**AGENDA
TECHNICAL REVIEW COMMITTEE
REGULAR MEETING
FEBRUARY 23, 2023
10:00 AM
CITY HALL COMMISSION CHAMBERS
204 ASH STREET
FERNANDINA BEACH, FL 32034**

Applicant Name: Matthew Phillips
Project Description: COA Memorial Park
Location: 1901 Island Walk Way
TRC Case Number: TRC 2023-0030

1ST ROUND REVIEW COMMENTS:

SITE DRAINAGE AND UTILITIES PLAN

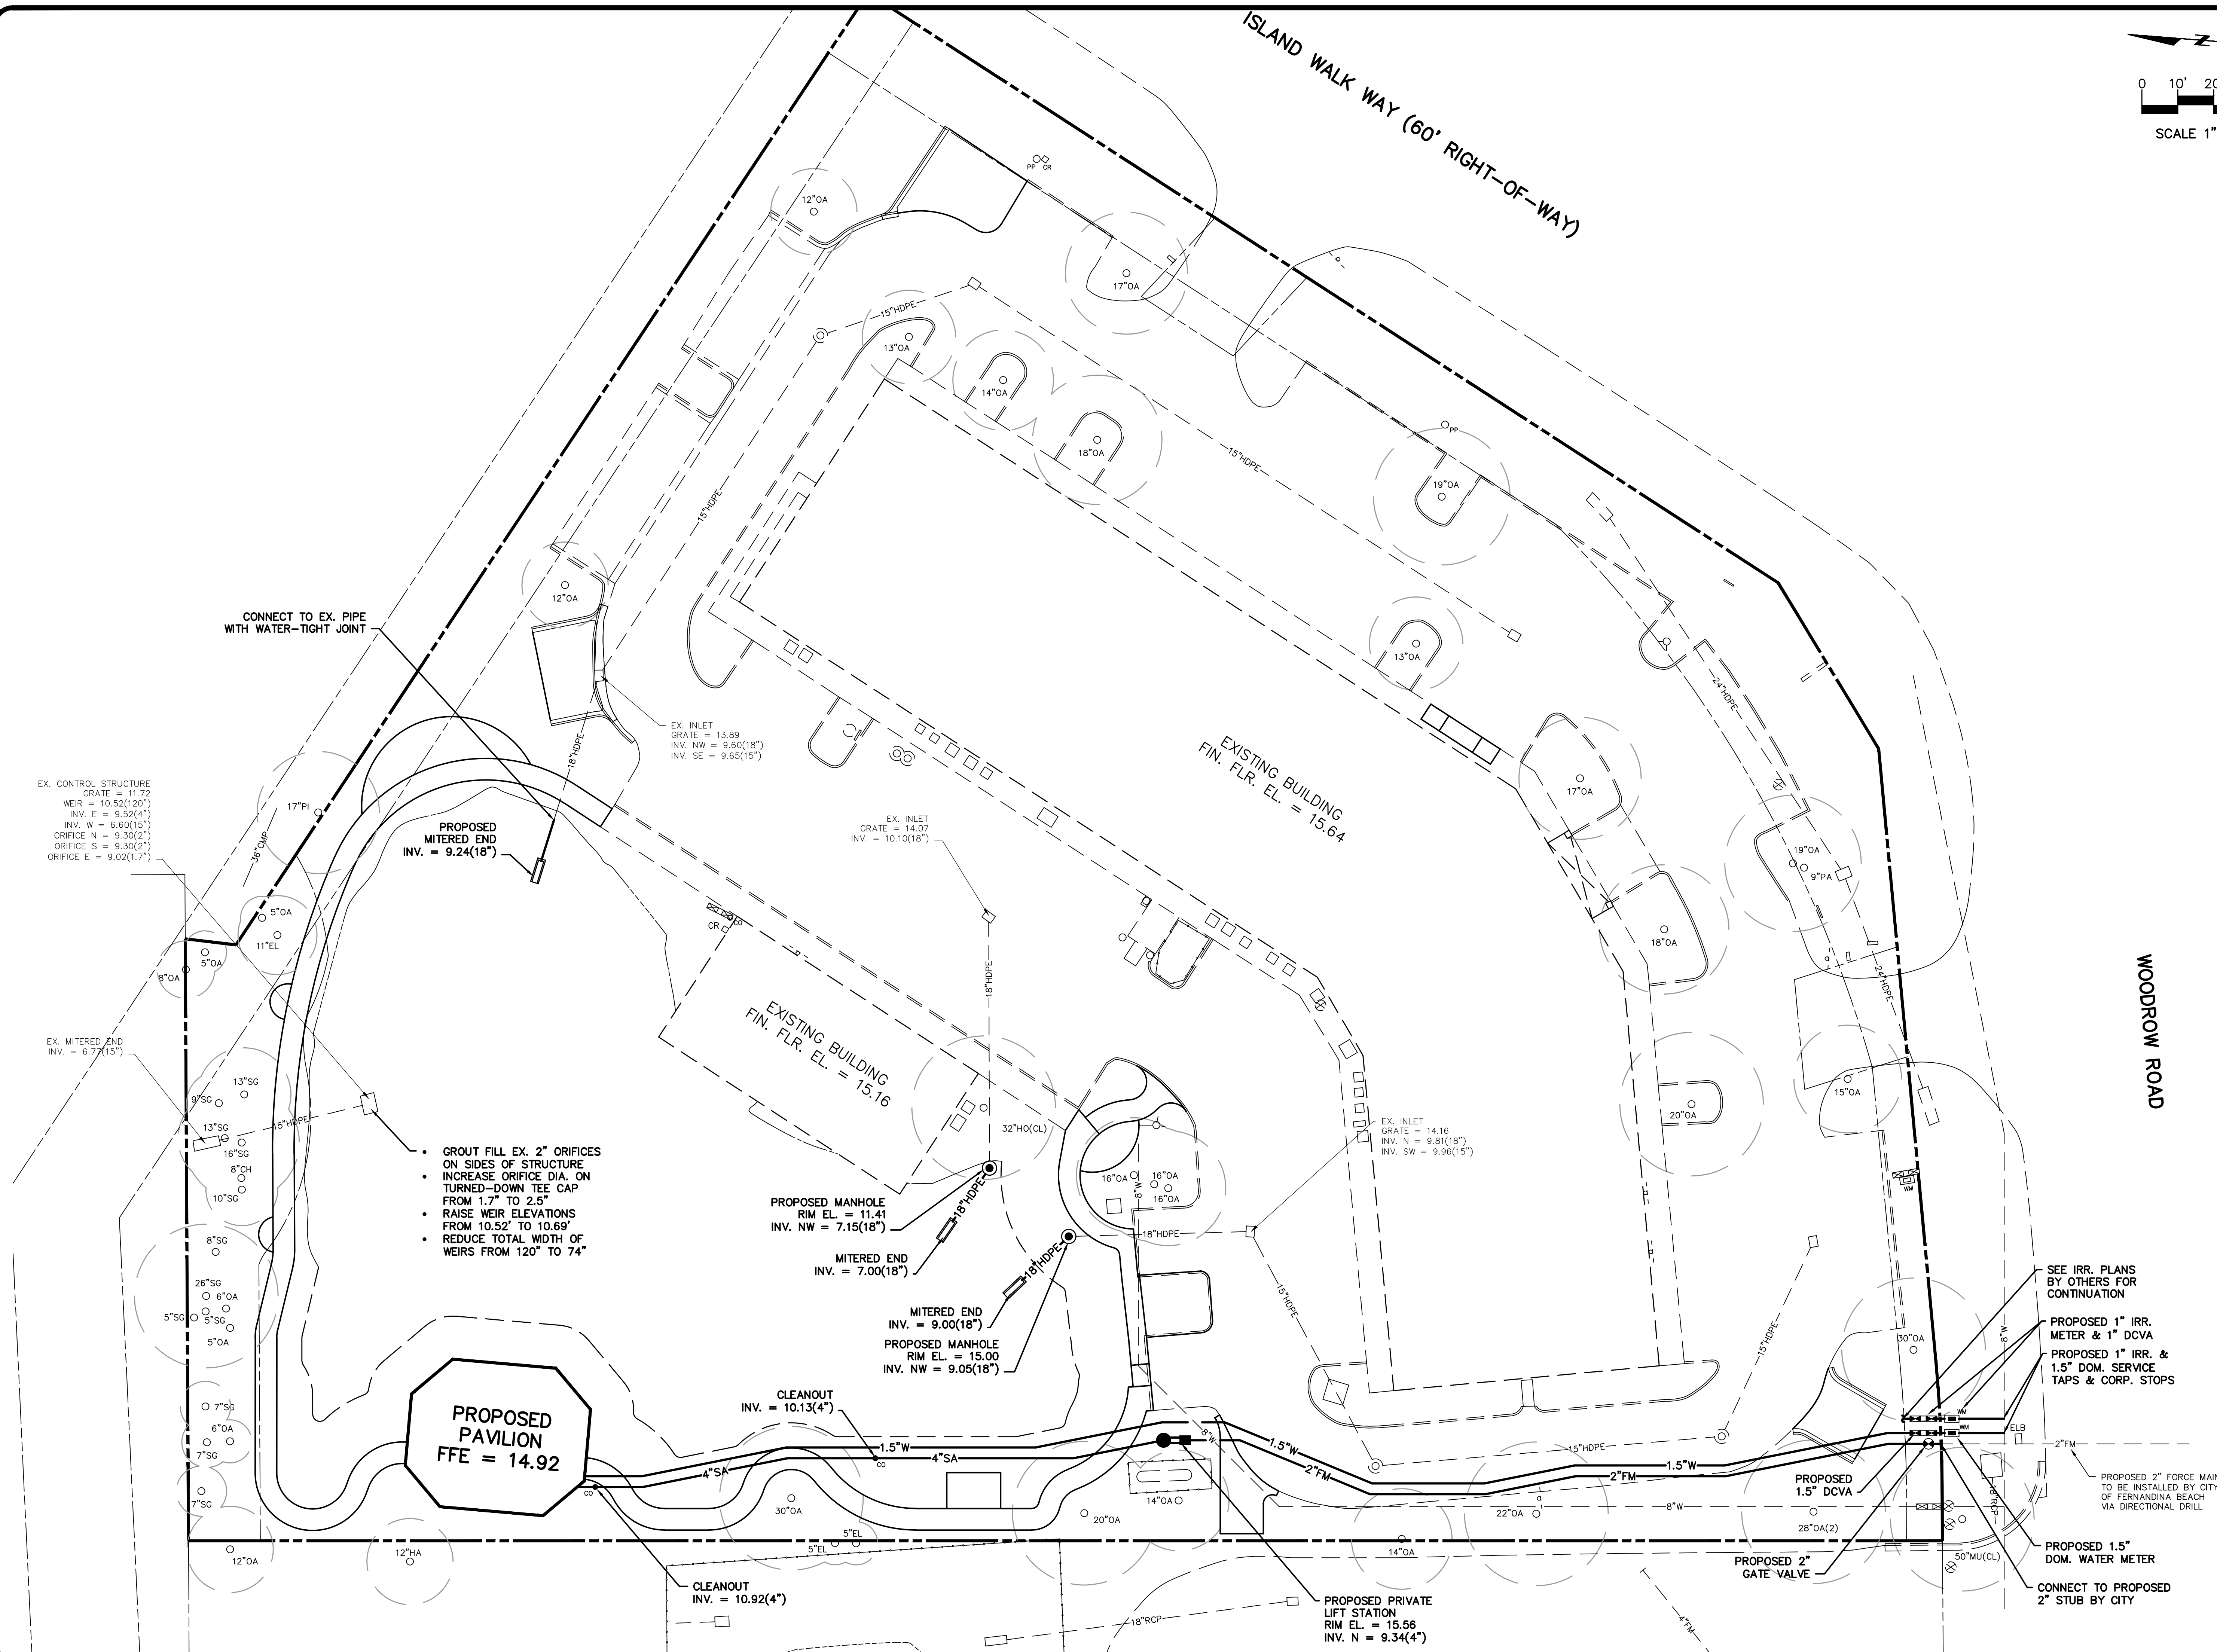
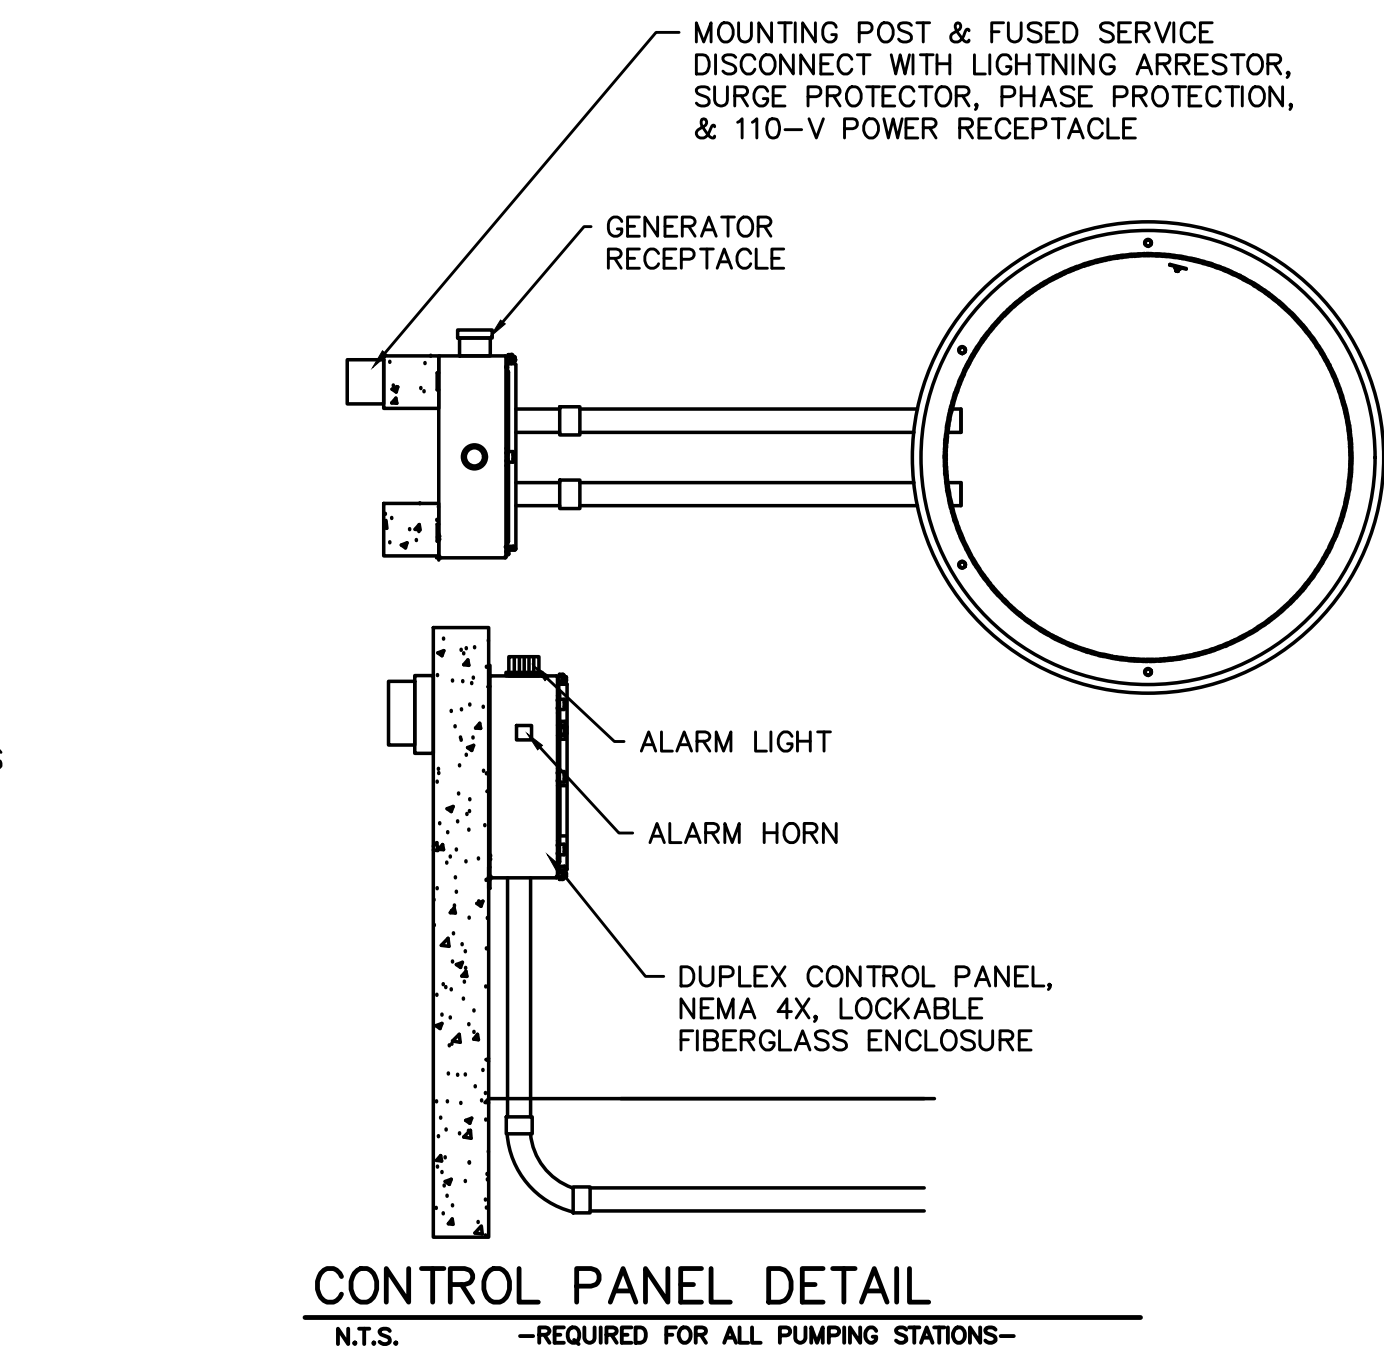
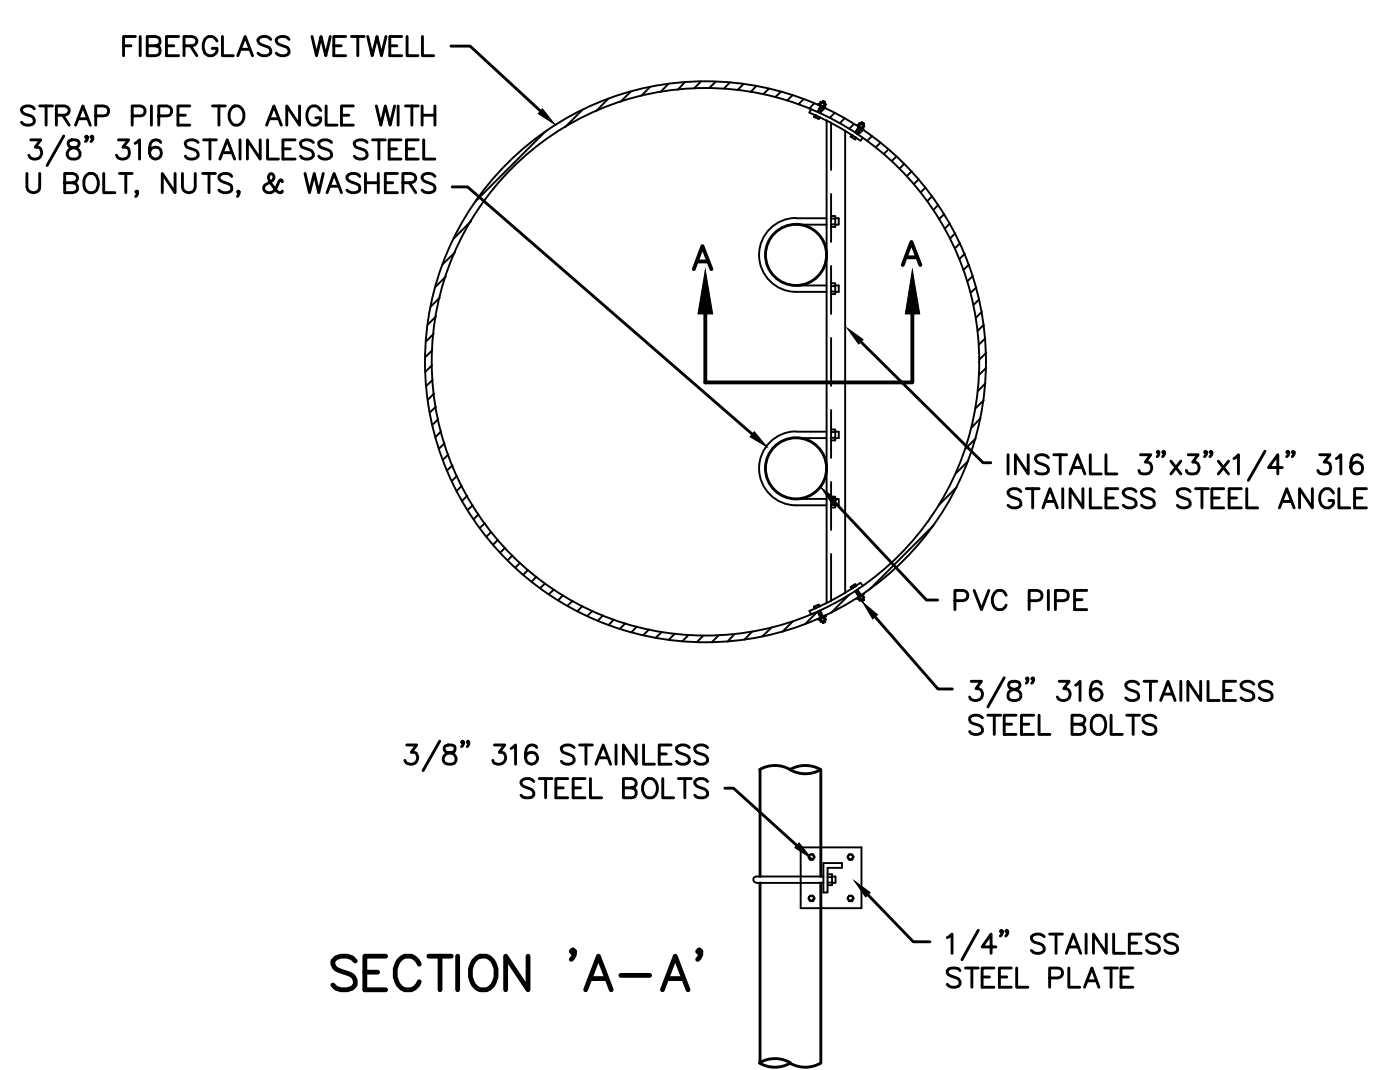
- Please provide on a sign by the Lift Station the number to call in case of an emergency.
- The valve box needs to be completely sealed in to prevent any drainage in case of a leak. Plumb it back to the wetwell with a p-trap to prevent gas build up as well.
